Re: St. Lucie Plant Unit 2
Docket No. 50-389
Renewed Facility Operating License No. NPF-16

Response to NRC Request for Additional Information (RAI) Regarding Extended
Power Uprate License Amendment Request

**Response to NRC Nuclear Performance and Code Branch
Request for Additional Information**

SNPB-16

Figure-34
Large Break LOCA ECCS Performance for Limiting Seismic Loads Analysis
0.6DEG/PD Break
Maximum Local Cladding Oxidation Percentage

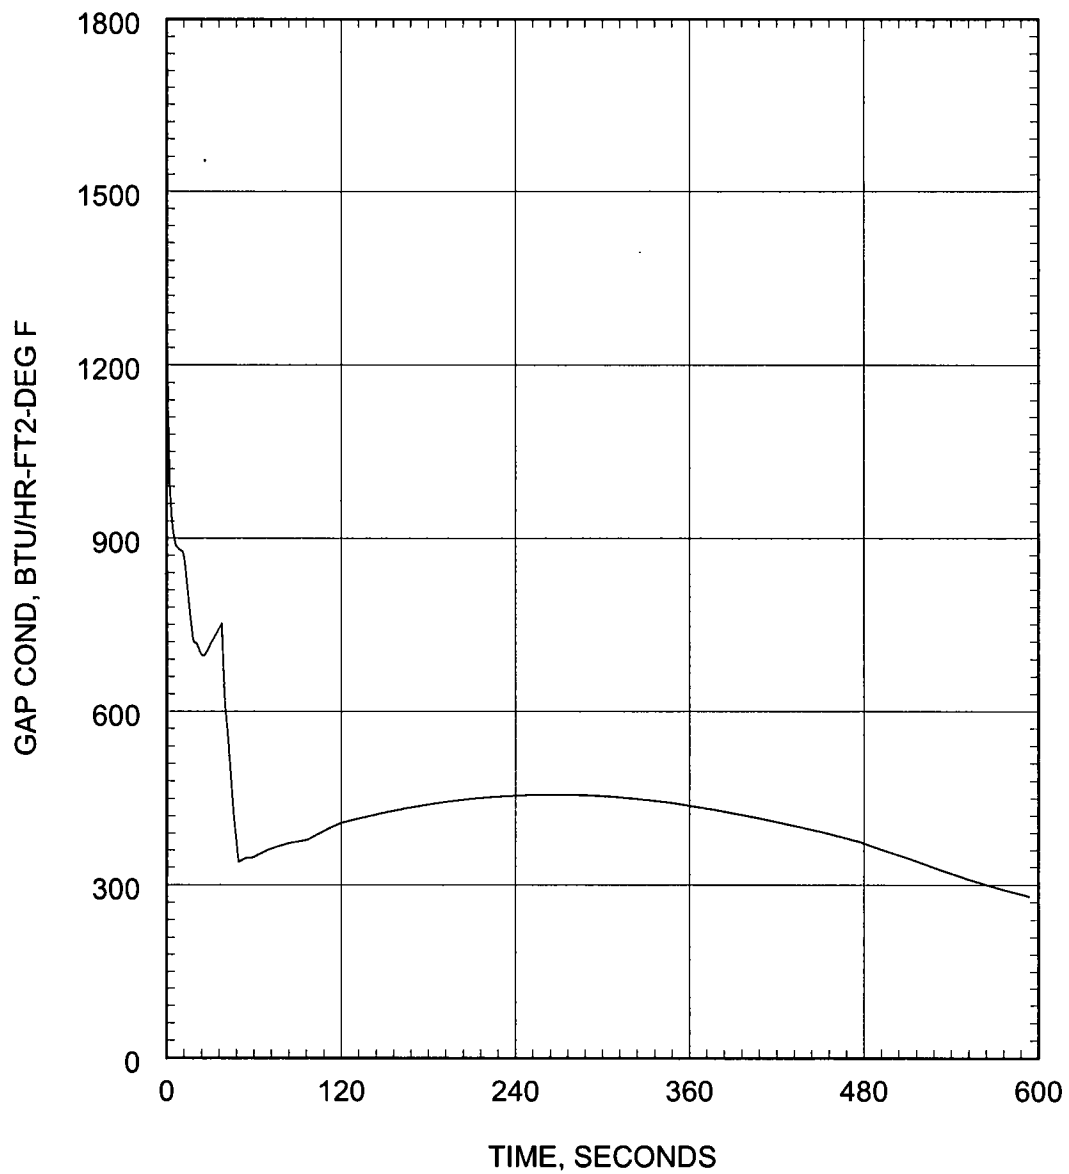
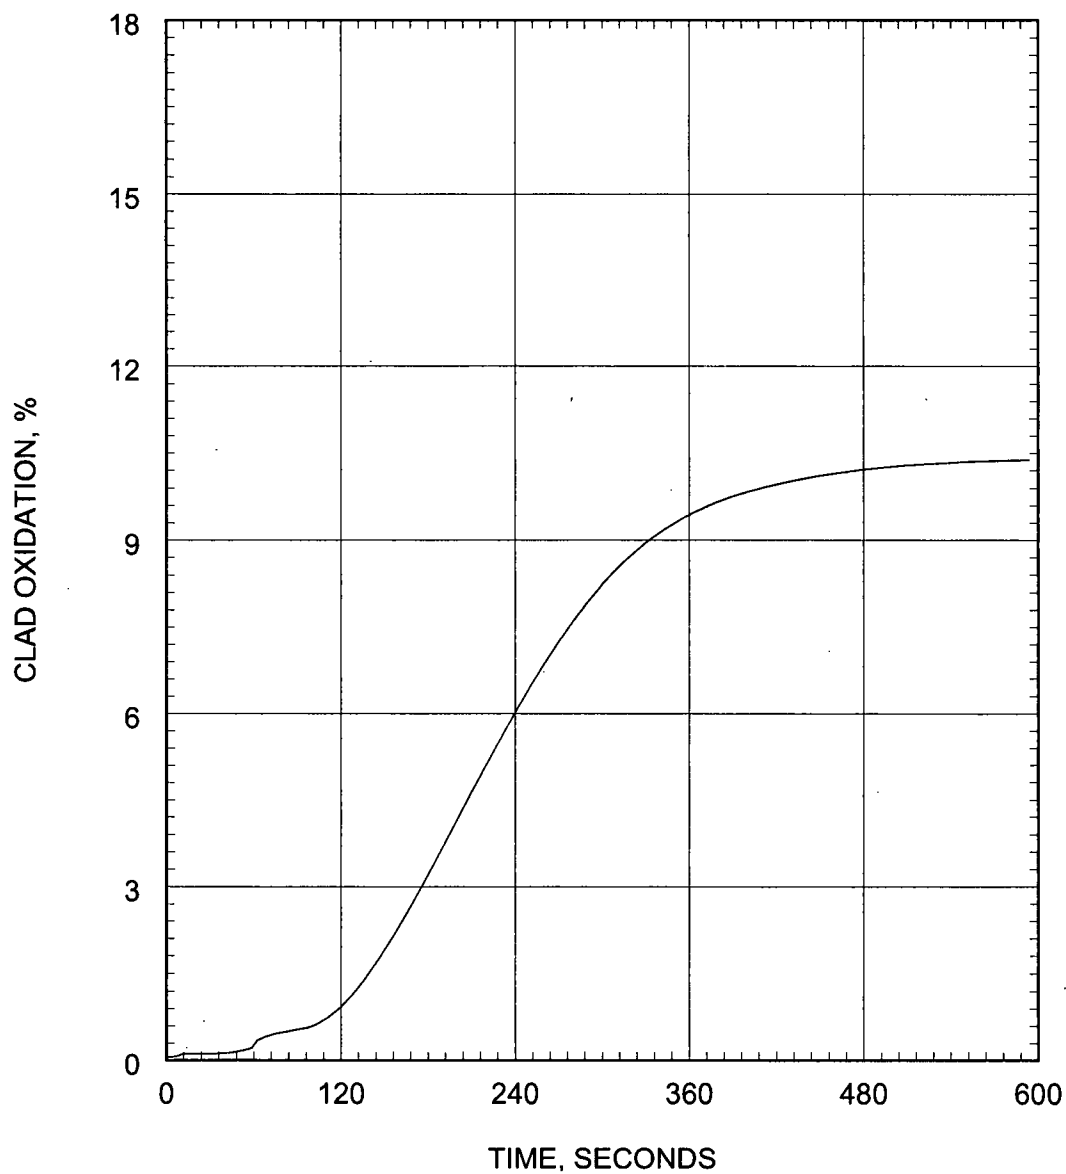
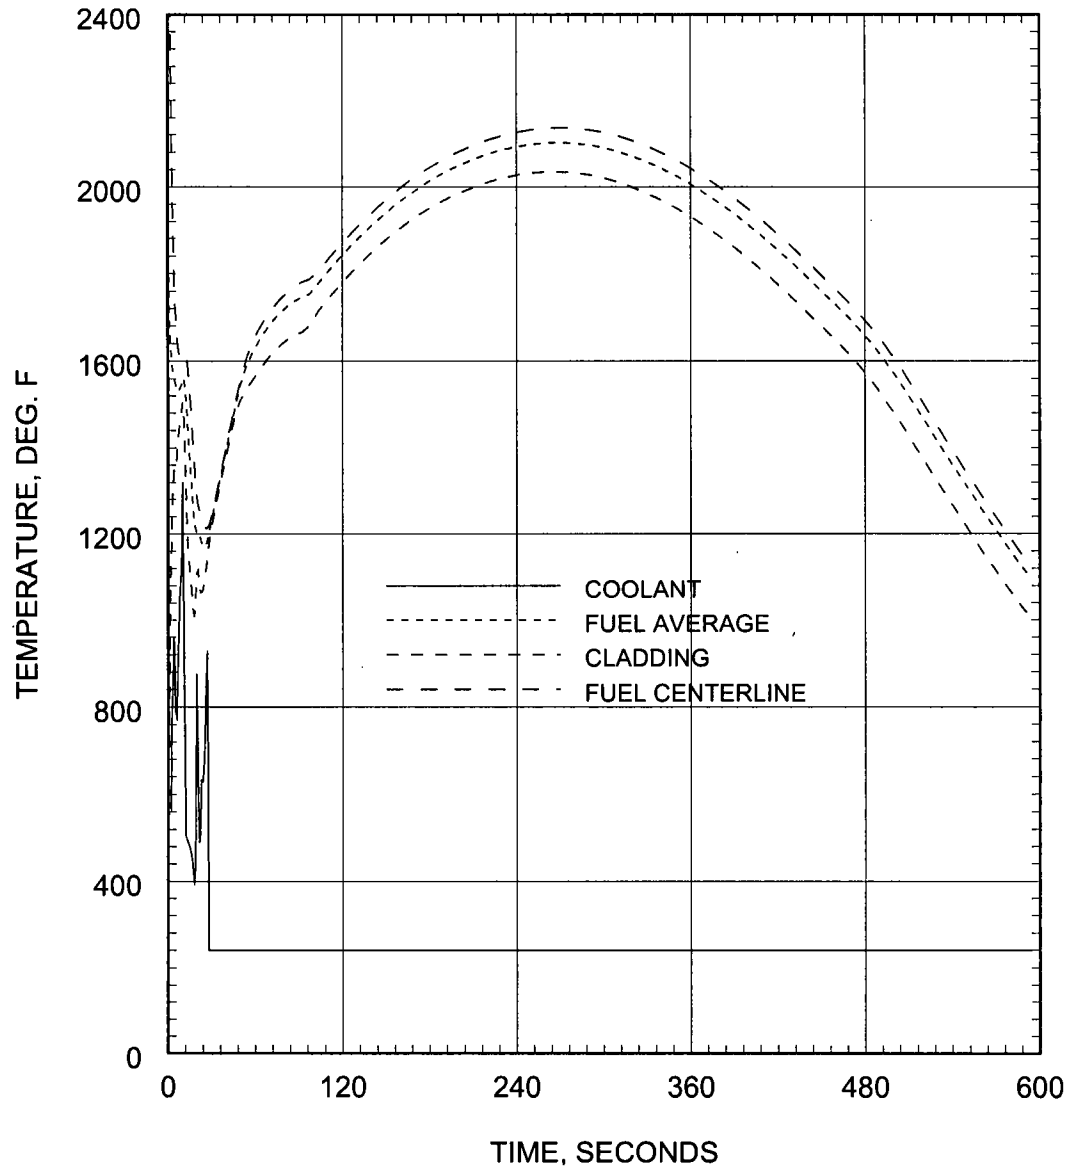
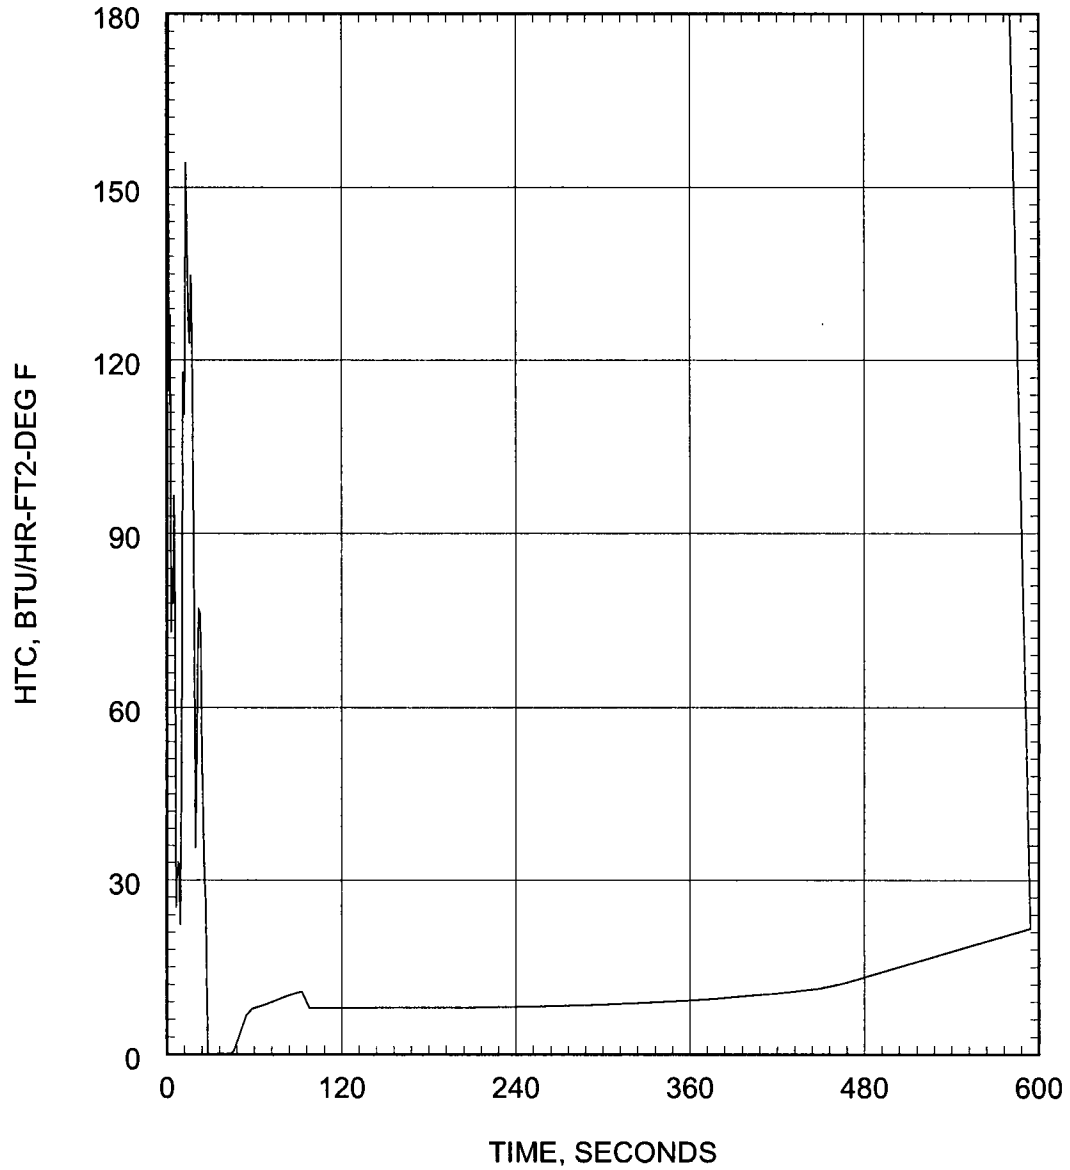
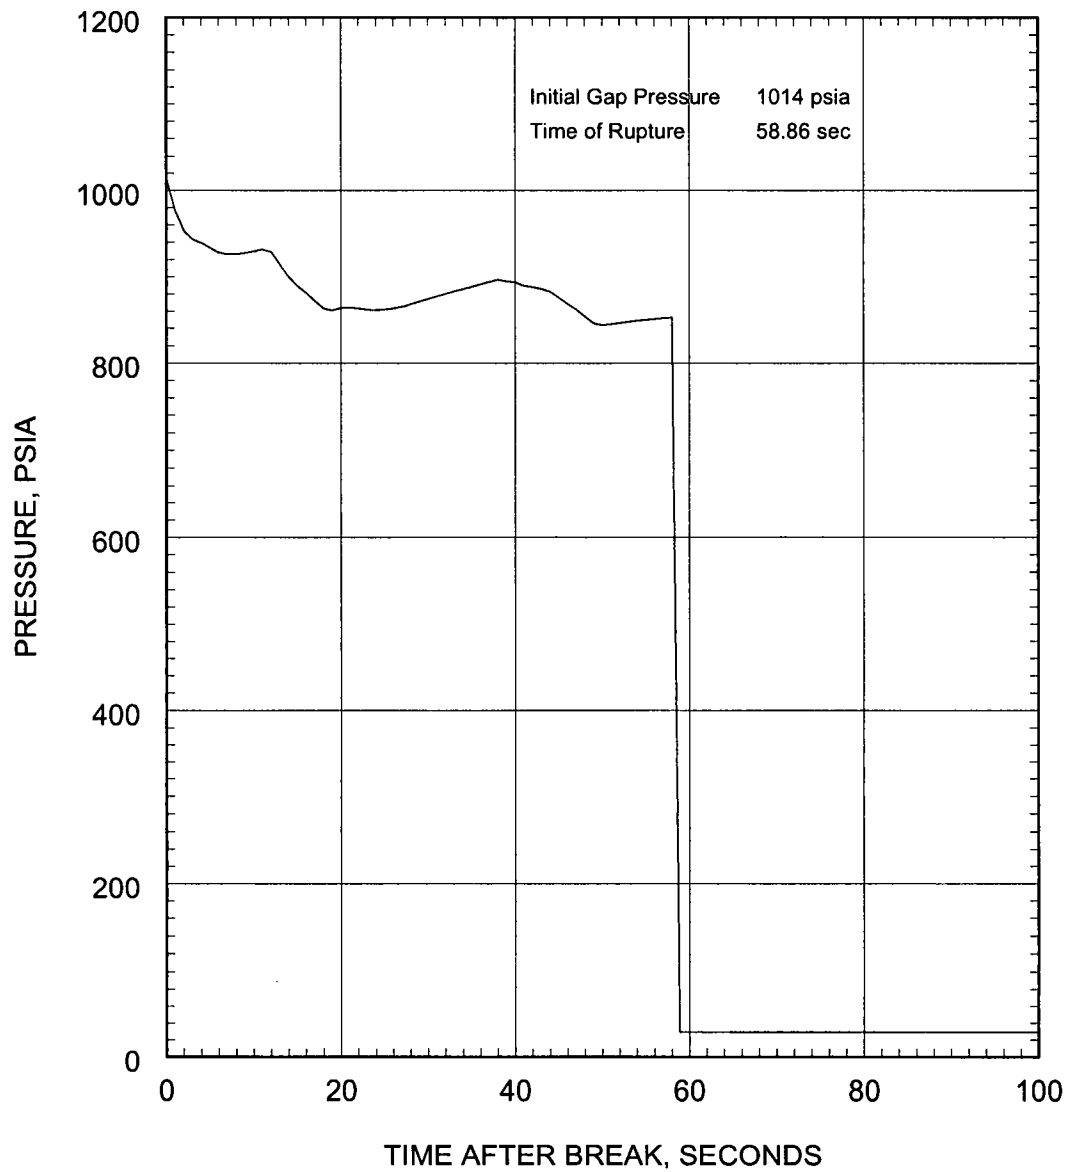
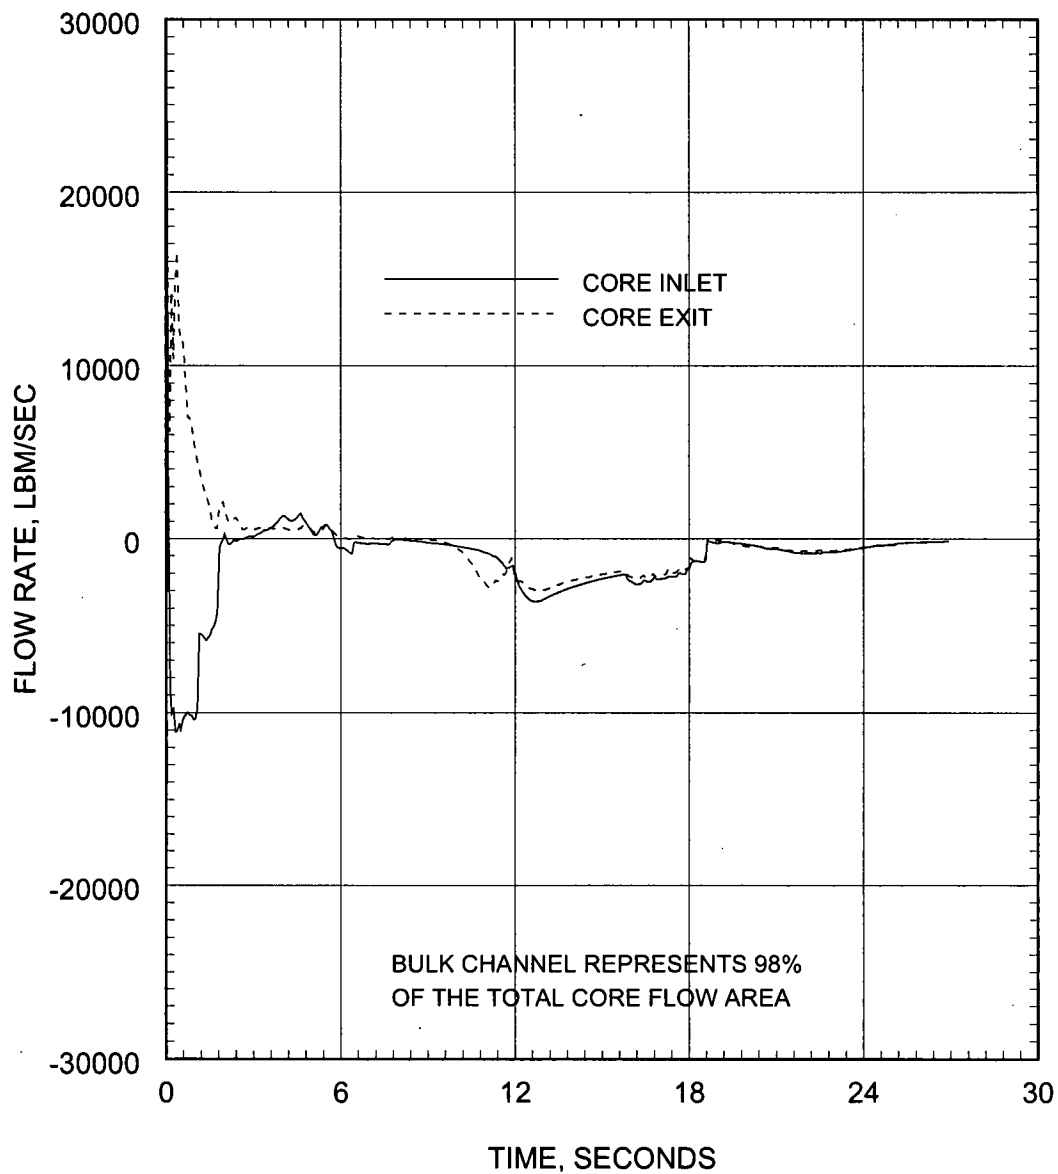
Please provide the results of the seismic LOCA loads analysis for the limiting break. Identify the maximum hot channel deformation/flow area reduction, the maximum hot bundle flow area reduction, the peak linear heat rate for the hottest rod in the assembly undergoing maximum deformation. Also, provide the linear heat rate for the bundle containing the rod with the max deformation. The analysis should provide the plots typical of the limiting large break LOCA analysis given in a chapter 15 analysis.

The seismic LOCA loads analysis confirms that 10CFR50.46 criteria related to peak cladding temperature and maximum cladding local oxidation criteria are satisfied for LOCA analysis of hot rods in peripheral fuel assemblies with maximum credible grid deformation, i.e., fully collapsed grids. The LOCA analysis is performed with the 1999 EM and conforms to guidelines for the evaluation of fuel assembly structural response to externally applied forces specified in NUREG 0800, SRP 4.2, Appendix A, Section IV, related to requirements from 10CFR50.46 ECCS Performance design basis criteria and use of maximum credible grid deformation. The maximum allowable LHR in peripheral distorted assemblies is determined to be 95% relative to the maximum LHR in the core.

The variables listed in Tables 2 and 3 are plotted as functions of time for the 0.6 DEG/PD break, the limiting LBLOCA, in Figures 19 through 38.
